Subject: #17-3903, Alex Ugorets, 2520 Shadywood Road,

Sketch Plan

Application Summary: The applicant is requesting comments via the sketch plan process for a proposed apartment building on vacant 3.11 acres to the south of the Freshwater Business Center. The apartment building would include 49 units and 51 underground parking stalls. A zone change will be required.

PROJECT NARRATIVE FRESHWATER APARTMENTS

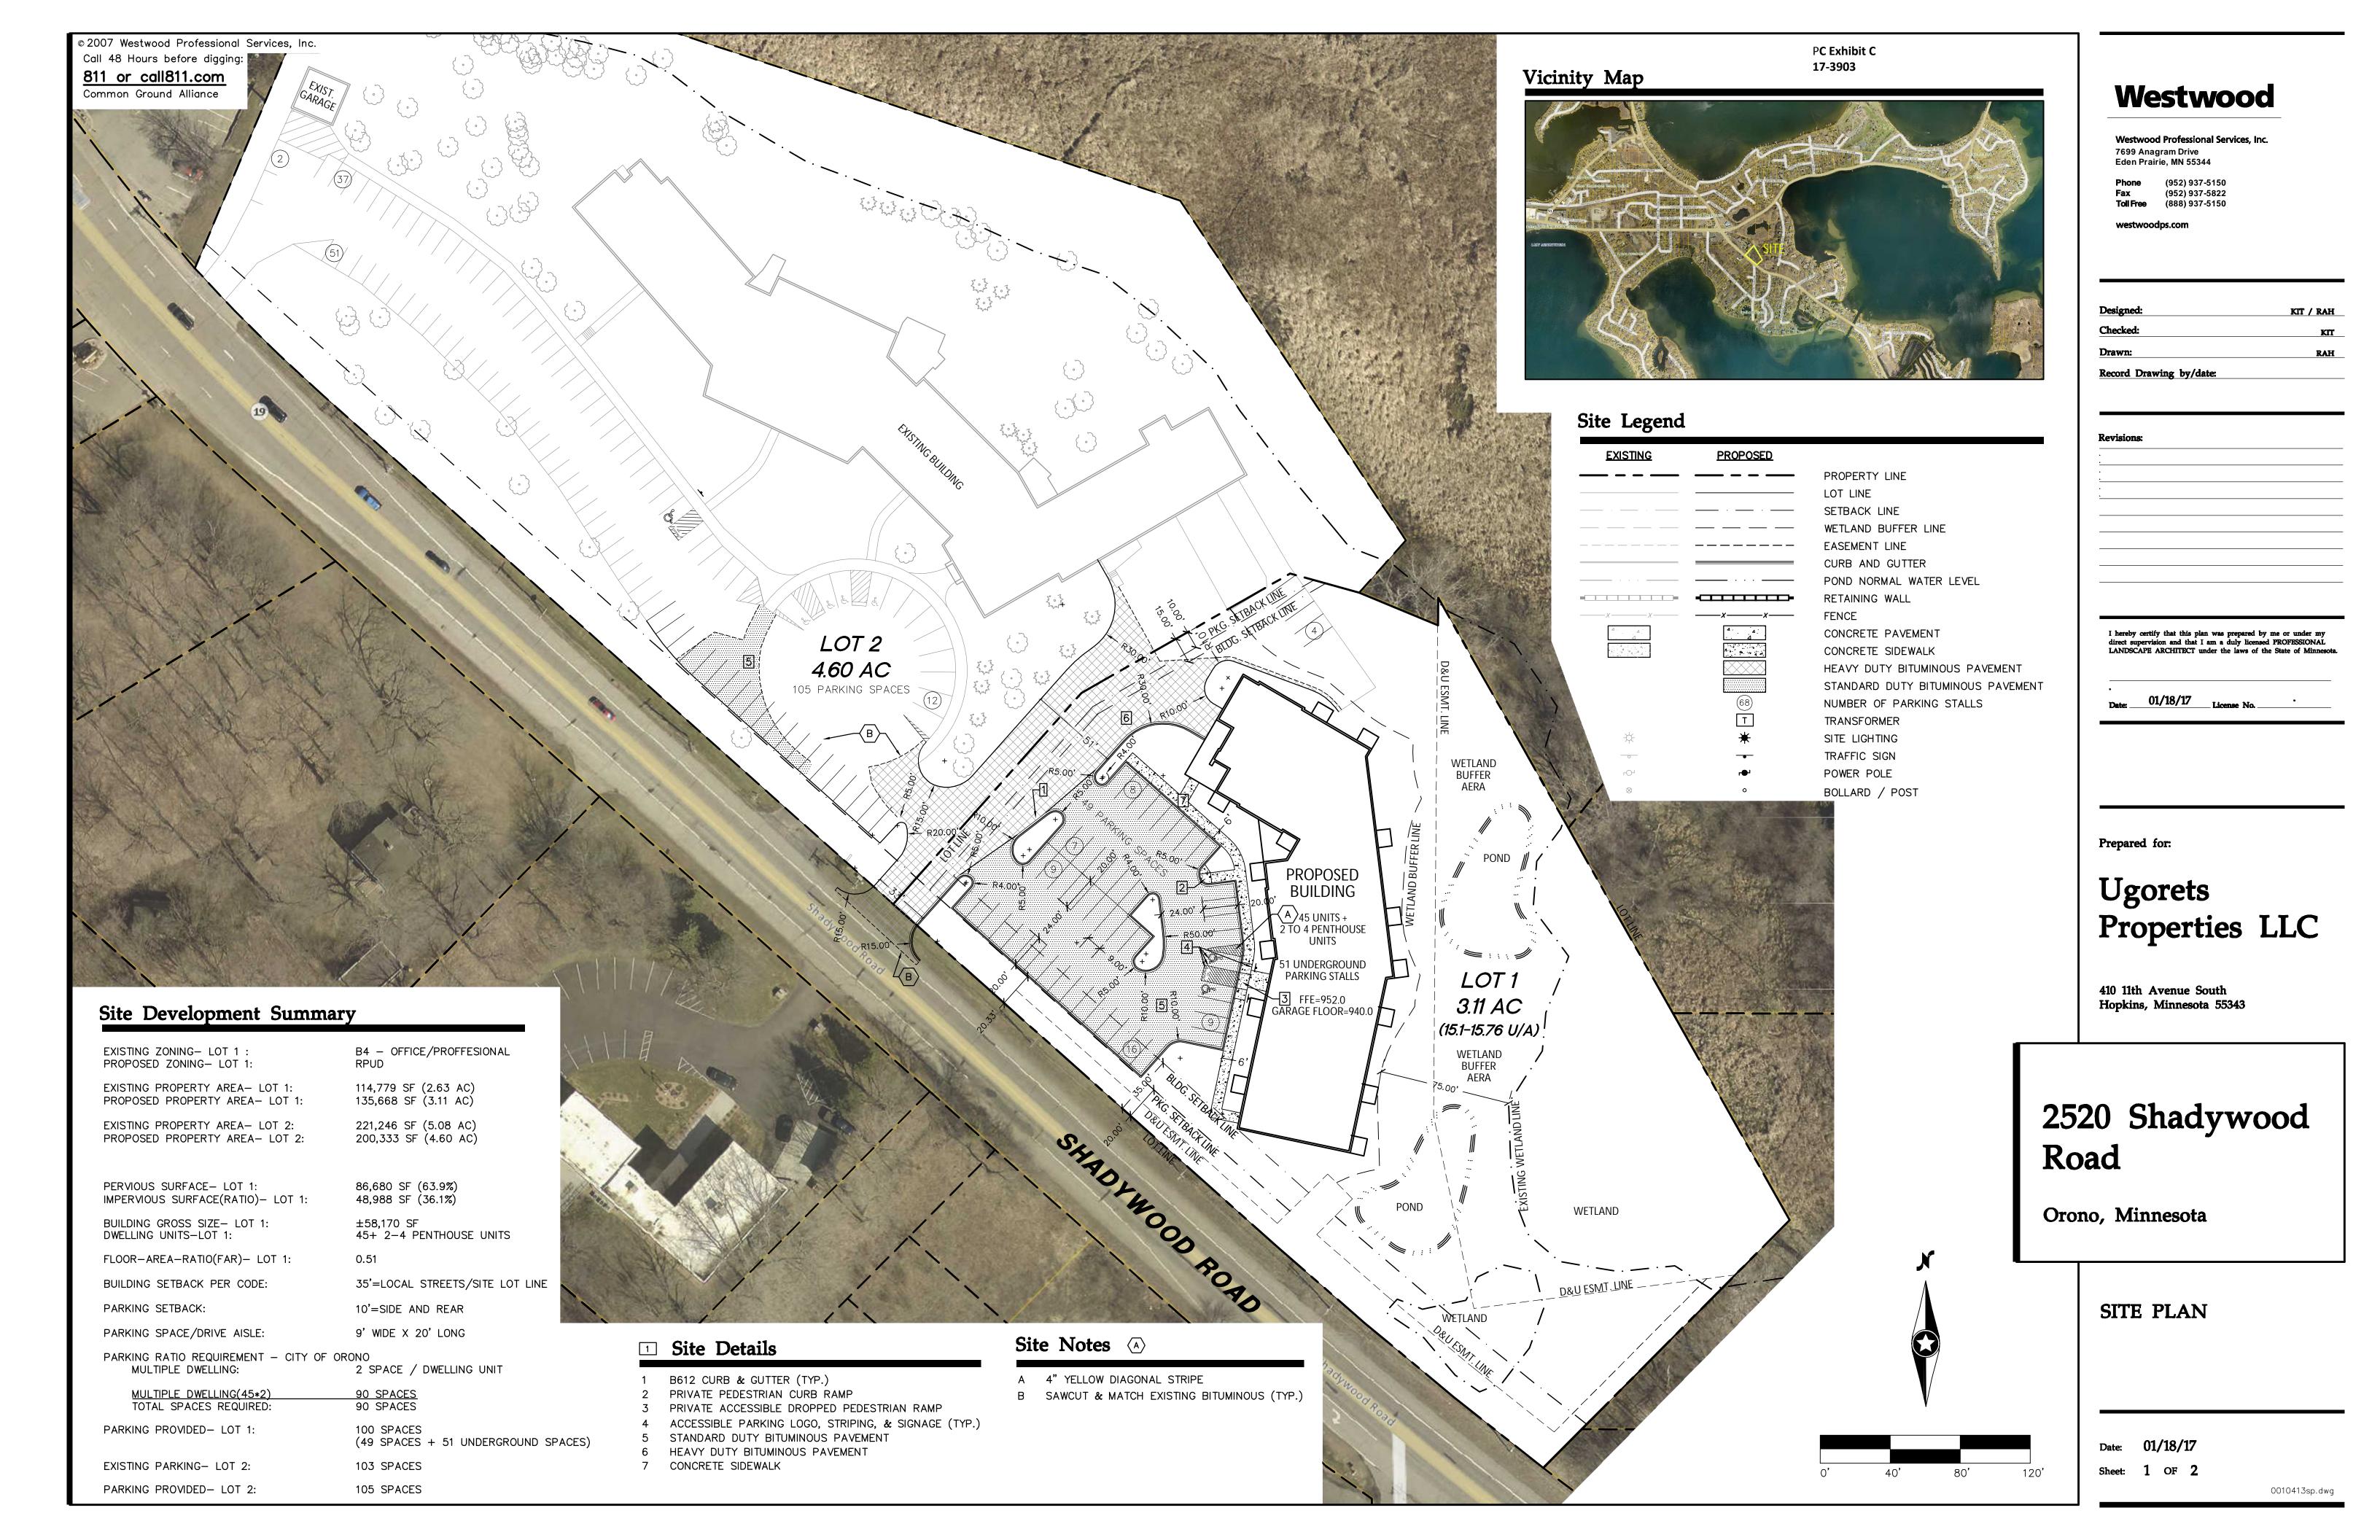
<u>Parking.</u> The proposal provides 100 parking spaces, a ratio of 2.04 spaces per unit. 51 of those spaces are covered, under the building, and 49 surface spaces are proposed. Two parking

The building is proposed to be 35 feet back from the Shadywood Road Right of way line and about 35 feet from the new side lot line to the north. The building will be 75 feet from the wetland.

<u>Grading.</u> The site slopes toward the east/ southeast, away from the street, dropping 12 feet in the first 119 feet. It appears that a substantial amount of fill will need to be brought in to accommodate the project. Further, the lot is wooded, the grading for the building, parking lot, and stormwater management will require the removal of most of the trees outside of the wetland.

<u>Utilities.</u> The project will be served by municipal water and sanitary sewer. Stormwater will need to be retained and treated as required by applicable stormwater regulation. Conceptual ponds are pictured.

<u>Hardcover/ structural coverage.</u> The proposal includes 48,988 sq ft (36.1%) of hard cover where 35% is the maximum permitted. The lot boundaries can be adjusted to avoid the need for a hardcover variance. A rough calculation of the structural converge shows 16,720 sq ft of structural coverage, or 12% of the lot area. There is no structural coverage maximum as the property is over 2 acres.
